**OHIO TURNPIKE AND
INFRASTRUCTURE COMMISSION**

ADDENDUM NO. 1

**PROJECT NO. 70-17-01
EMBANKMENT REHABILITATION PROJECT
EASTBOUND MAINLINE
MILEPOST 222.20 TO MILEPOST 222.45
MAHONING COUNTY, OHIO**

MODIFICATIONS TO PLAN SHEET NOS. 3, 4 AND 5 OF 5

SLOPE REPAIR TYPICAL

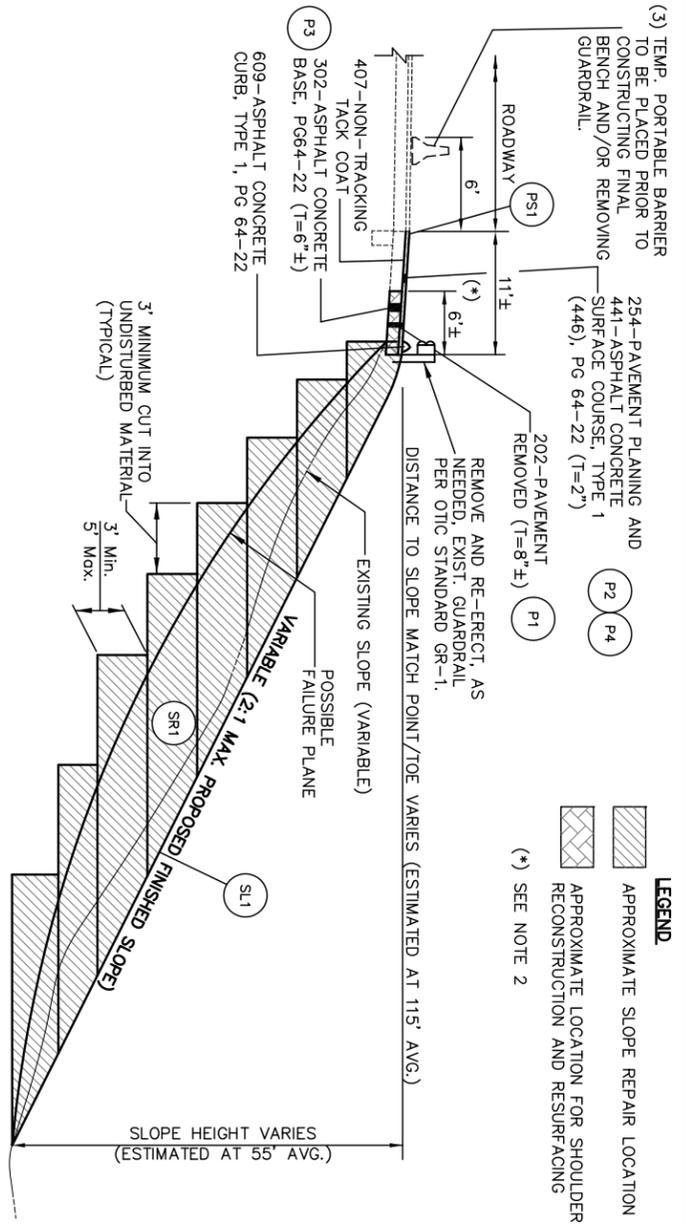
Q#2 Note 3 on Sheet 3 states we are to remove & replace the slope material and embankment material furnished, placed & compacted. The last sentence of note 3 states all excavated material, not reused, shall be disposed of. My questions is: Can a “Borrow” item be added. If the material turns out to be suitable, it remains on-site and is reused. If it is unsuitable, it is hauled off & replaced using the borrow item. The borrow item should include hauloff & replacement material. The excavation & embankment items should cover the item of work with no trucking off-site.

Q#3 The slope repair typical detail on page 3 of 5 shows the thickness of the 302 Asphalt base at 6”, and the quantity table below the detail on the same page calls out the 302 Asphalt base at 8” thick. Can you please specify what the plan thickness is for the 302 Asphalt Concrete Base item?

A#2 Plan Sheet Nos. 3 of 5 and 5 of 5 have been reviewed and revised. Note 3 on Plan Sheet No. 3 of 5 has been revised to provide clarity regarding the reuse of existing embankment material. Additionally, plan quantity for Item No. 203 – Embankment has been revised from 22,000 to 11,000 CY on the summary table on Plan Sheet 3 of 5. Additionally, a quantity of 11,000 CY of Item No. 203 – Borrow, As Per Plan has been added to the summary table on Plan Sheet 3 of 5 to provide the Contractor with a pay item if borrow is required, and the note below the table has been revised as well. A plan note has been added on Plan Sheet 5 of 5 providing additional information and clarification regarding Item No. 203 - Borrow, As Per Plan, and Item 203 - Embankment. The unit prices bid for each Item No. 203 shall remain firm regardless of the deviation from estimated quantities and actual quantities installed and accepted, anything provided in the Contract Documents notwithstanding. The Estimated Quantities on Plan Sheet No. 5 of 5 has been revised to include 11,000 CU.YD. of Item No. 203 - Borrow, As Per Plan, and the quantity of Item No. 203 - Embankment has been revised from 22,000 to 11,000. Similar revisions have been made to the Estimated Quantity Worksheet. Revisions to Plan Sheet Nos. 3 and 5 of 5 and the Estimated Quantity Worksheet are included with this Addendum No. 1.

A#3 *This Addendum No. 1 revises Plan Sheet No. 3 of 5 to modify the thickness specified for Item No. 302 - Asphalt Concrete Base from 8" to 6". Additionally, the quantity for Item No. 302 - Asphalt Concrete Base is revised from 115 to 90 CY in the table on Plan Sheet No. 3 of 5. The general summary on Plan Sheet No. 5 of 5 is revised accordingly. Revised Plan Sheet Nos. 3 and 5 of 5 and the revised Estimated Quantity Worksheet are incorporated into the Contract Documents through this Addendum No. 1.*

3. THE EXISTING SLOPE SHALL BE BENCHED AS SHOWN ON THE PLANS AND EMBANKMENT AND/OR BORROW MATERIAL SHALL BE FURNISHED, PLACED AND COMPACTED IN ACCORDANCE WITH ITEM 203. ALL EMBANKMENT MATERIAL SUPPLIED UNDER ITEM 203 - EMBANKMENT, SHALL BE TESTED BY THE COMMISSION TO ENSURE THAT THE MATERIAL CONFORMS TO A-4a, A-6a, OR A-6b SOIL CLASSIFICATION AND THAT MATERIAL HAS A MAXIMUM DRY DENSITY OF 110 PCF OR GREATER AS DETERMINED BY ODOT SUPPLEMENT 1015. THE CONTRACTOR MAY REUSE SOME OR ALL OF THE EXISTING SLOPE MATERIAL PROVIDED THE EXISTING SLOPE MATERIAL IS REWORKED AND MODIFIED, AT THE CONTRACTOR'S EXPENSE, TO MEET THE SOIL REQUIREMENTS SPECIFIED ABOVE. ALL EXCAVATED MATERIAL NOT REUSED, SHALL BE DISPOSED OF IN ACCORDANCE WITH SP 105.

ITEM SPECIAL - BENCHING SLOPE DRAIN DETAIL

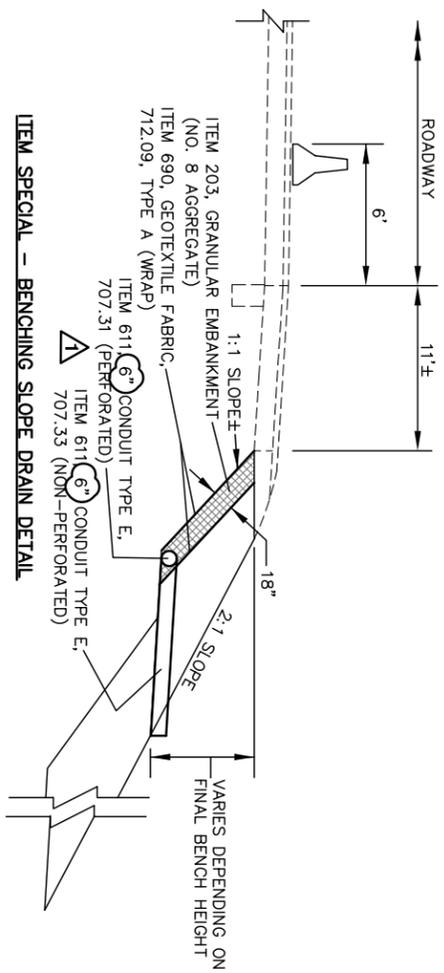
Q#4 The detail shown on page 4 of 5 (Benching Slope Drain Detail) shows Granular Embankment above the pipe that varies in height. The granular embankment is incidental to the Benching Slope Detail. Given that field conditions could affect this quantity greatly, could an item be added to the project for Granular Embankment?

Q#5 Can the size of the type E conduit be provided for the detail on page 4 of 5 (Benching Slope Drain Detail)?

A#4 *This Addendum No. 1 revises Plan Sheet No. 4 of 5. The Note for Item Special – Benching Slope Drain now includes 362 C.Y. of Item No. 203 – Granular Embankment as a separate pay item and is no longer incidental to Item No. Special – Benching Slope Drain. Plan Sheet No. 5 of 5 has been revised as well through this Addendum No. 1. Item No. 203 – 362 CU.YD. Granular Embankment has been added to the ESTIMATED QUANTITIES. Revised Plan Sheet Nos. 4 and 5 of 5 and the revised Estimated Quantity Worksheet are incorporated into the Contract Documents through this Addendum No. 1.*

A#5 *This Addendum No. 1 revises Plan Sheet No. 4 of 5 so the detail now specifies the conduit size as 6". Revised Sheet No. 4 of 5 is incorporated into the Contract Documents through this Addendum No. 1.*

THE PLANS INCLUDE APPROXIMATELY 362 C.Y. OF ITEM 203 - GRANULAR EMBANKMENT. THIS ITEM SHALL CONFORM TO THE PLAN REQUIREMENTS AND APPLICABLE PORTIONS OF ITEM 203. ALL LABOR, EQUIPMENT, MATERIALS AND INCIDENTALS NEEDED TO COMPLETE THIS ITEM SHALL BE INCLUDED IN THE UNIT BID PRICE PER CU.YD. OF ITEM 203 - GRANULAR EMBANKMENT INSTALLED AND ACCEPTED.
